Subject: UMTRA PROJECT - GEN

Review Comments on "Standard Review Plan for Surface Water Hydrology
 and Erosion Protection" and "Design of Rock Armor for Uranium Mill
 Tailings Embankments"

DESIGN OF ROCK ARMOR FOR URANIUM MILL TAILINGS EMBANKMENTS

Figure 2 - Angle of Repose for Rock (Ref. 12)

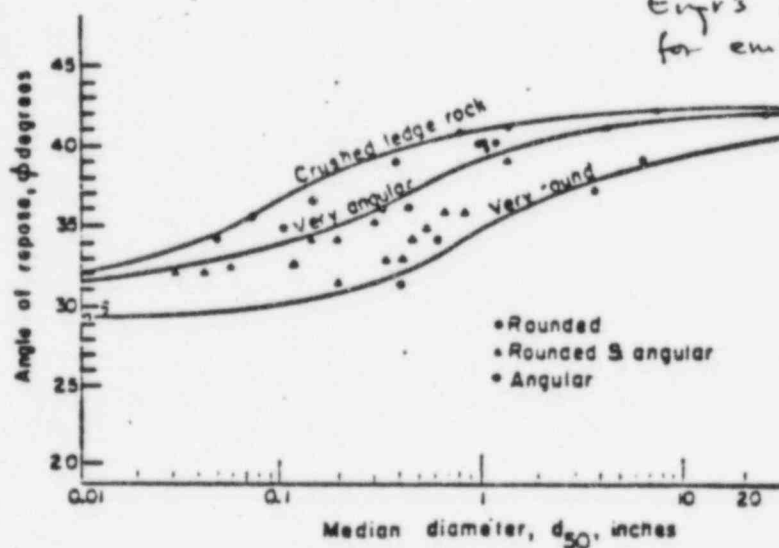
too high (our experience at ship rock using the Corps of Eng'r's formula: $n \approx 0.025 \text{ to } 0.03$ for embankment top).

Figure 3 - Intensity vs. Duration for Local PMP

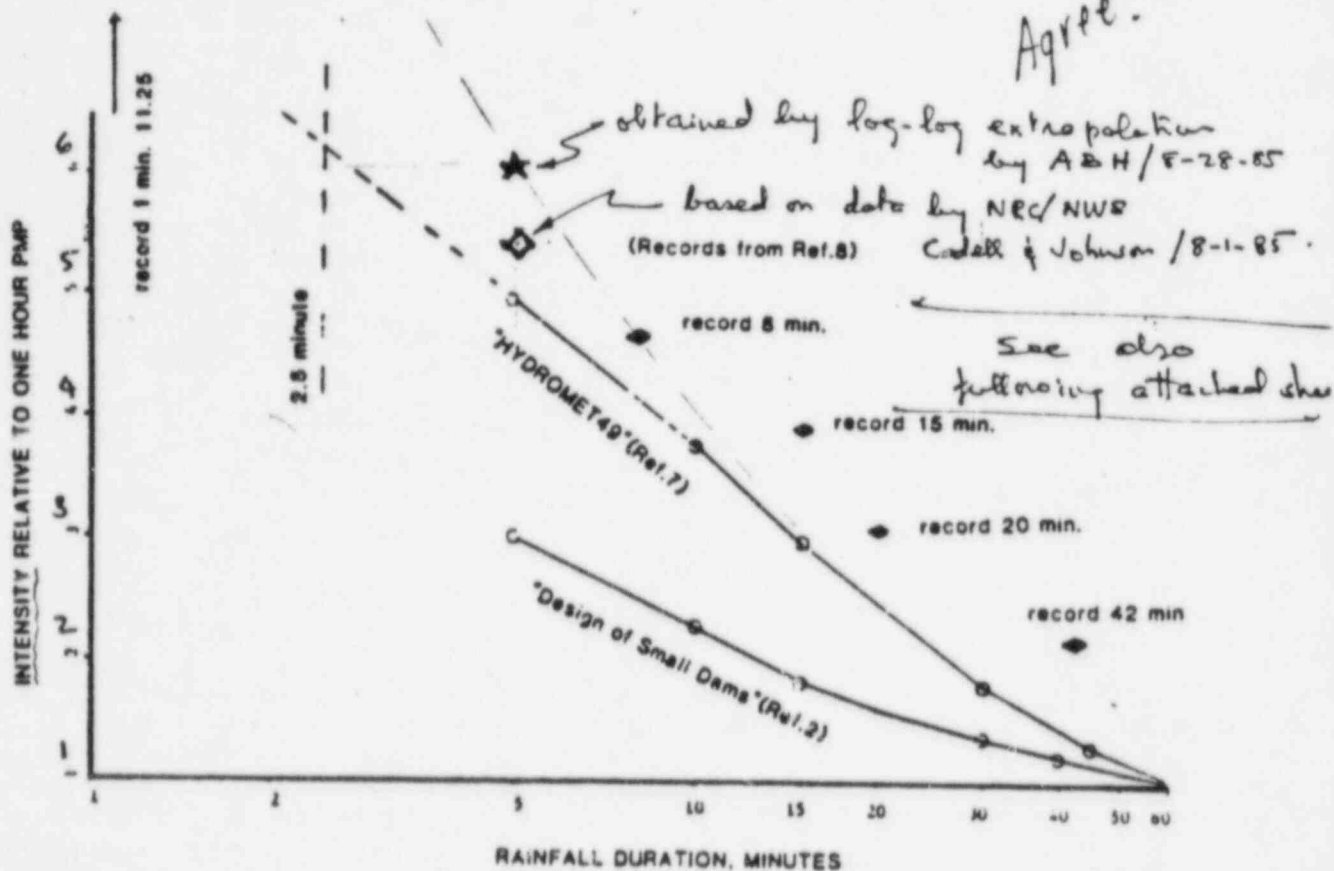
ADH
Agree?
ADH?

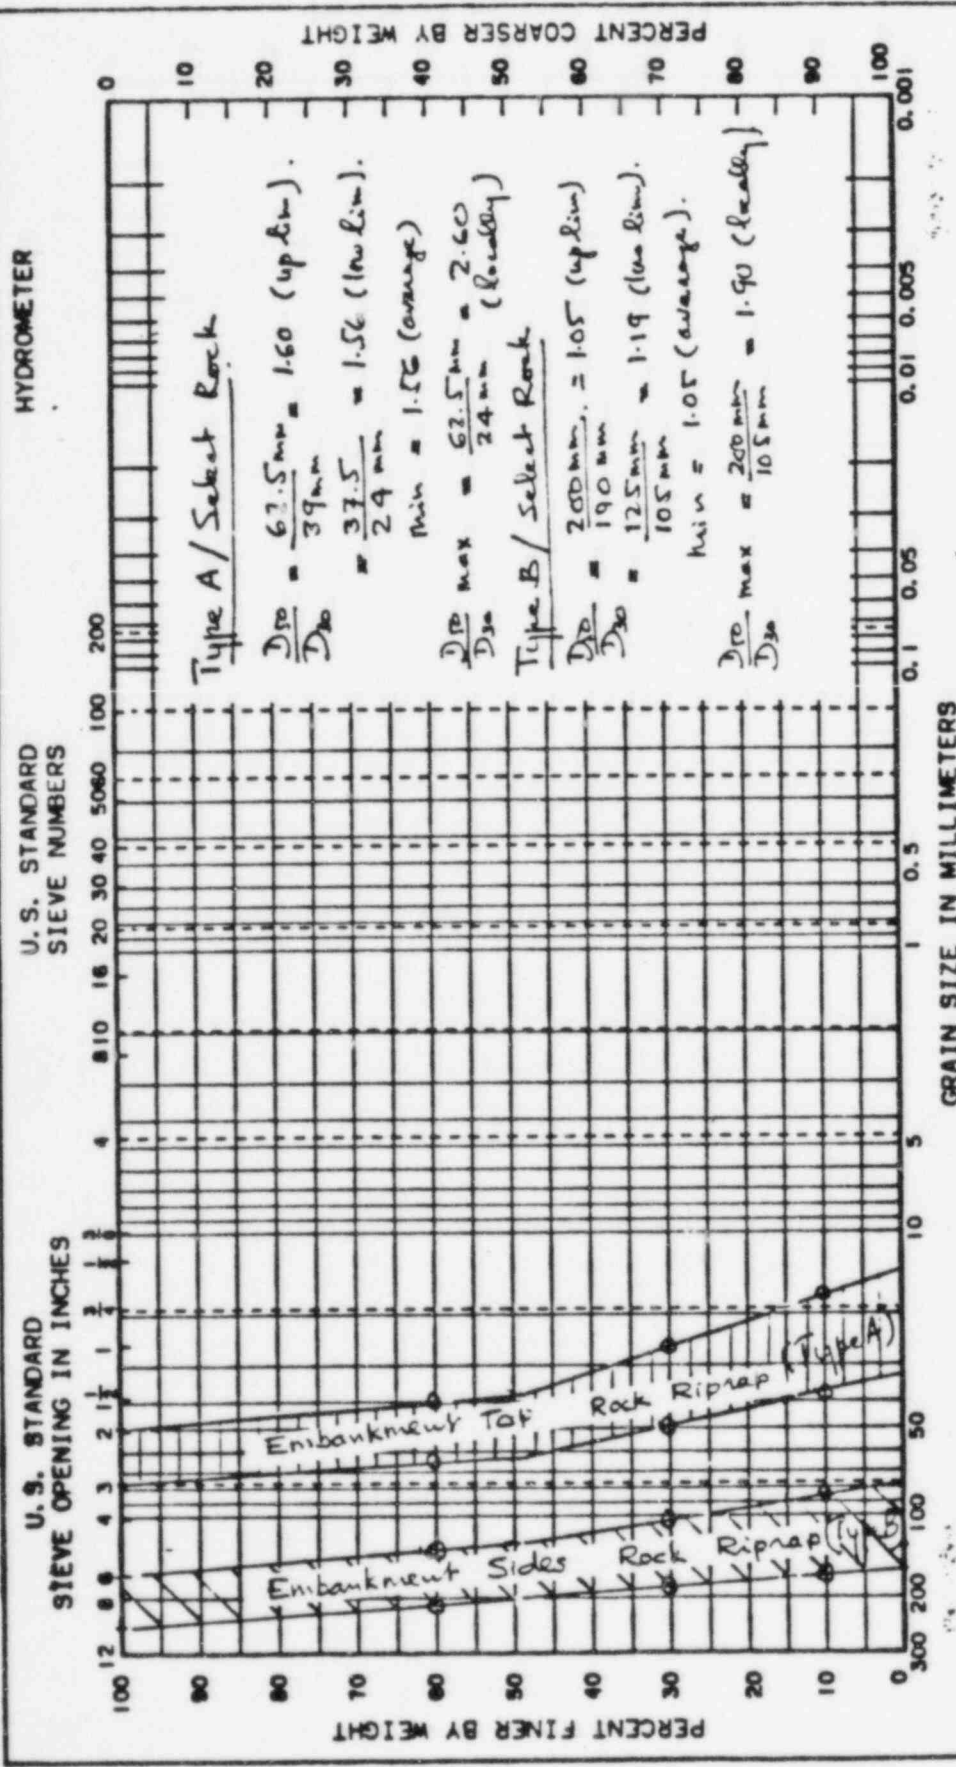
In our experience D_{50}/D_{30} (side slope) = 1.05 to 1.19 on the average with locally 1.90 maximum possible for similar size rock, using Corps of Eng's. The stated d_{50} rock diameters for the top and side slopes were 1.5" and 4.5" gradation respectively, which is somewhat less than the calculated rock diameters. If the calculated rock diameters of 2.0" and 8.1" were specified, it would not be necessary to repeat the runoff calculations, since it has been shown in Section C.1.c that increasing the rock size would have the effect of decreasing the peak runoff from the top layer, which is the design basis for both the top and side layers.

See following attached page

With regard to side slopes, our present design calls for $D_{50} > 5$ inches for the side slopes, and under H&R # 49 (proposed change) **DRAFT**, we will recommend $D_{50} > 8.1$ inches using the Safety Factor method.

FIGURE A1 - RUNOFF FROM AN ARMORED SLOPE

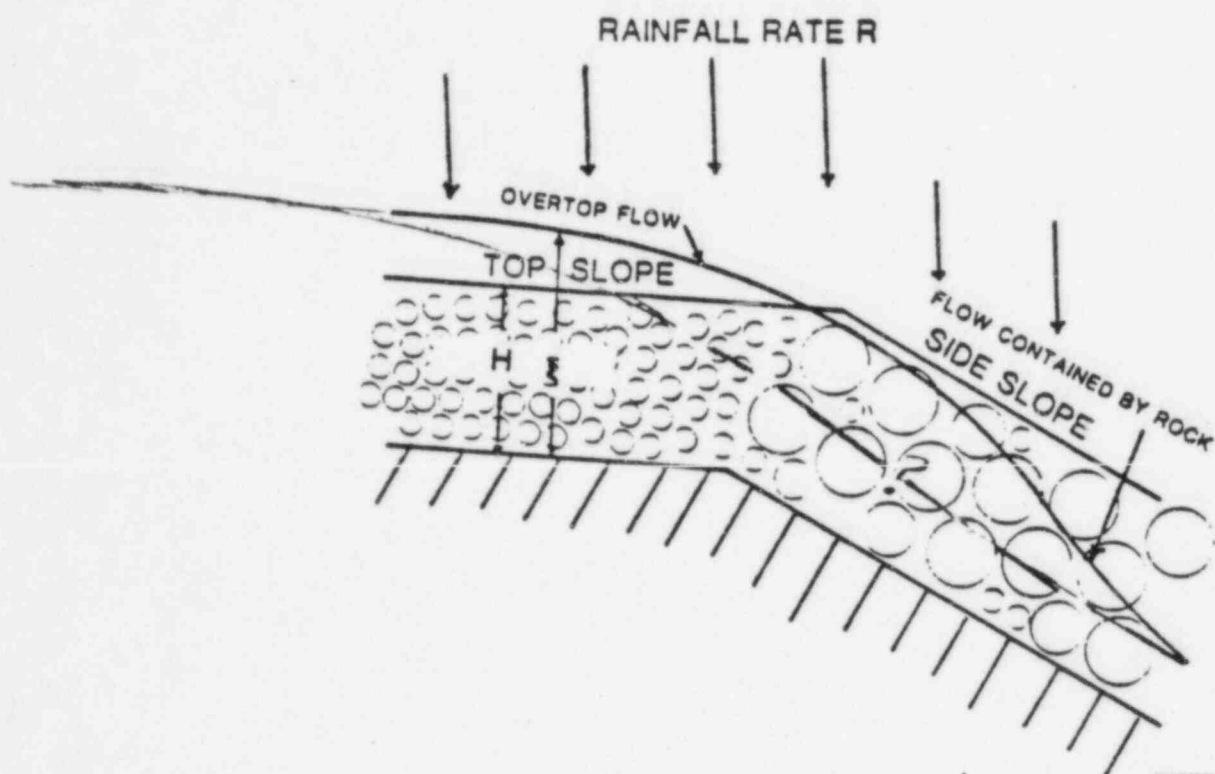
See comment by
GRT on bottom of p. 35

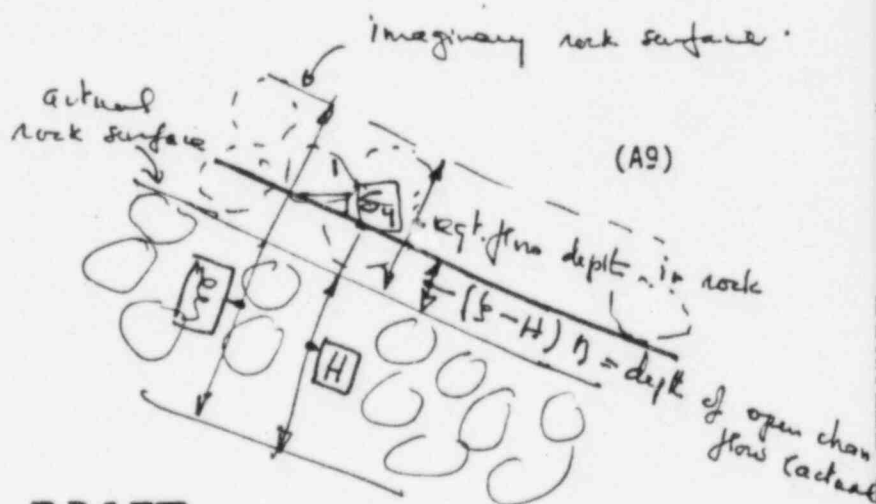
explain and elaborate
 with sketch if possible.
 non-uniform flows
 (A8)
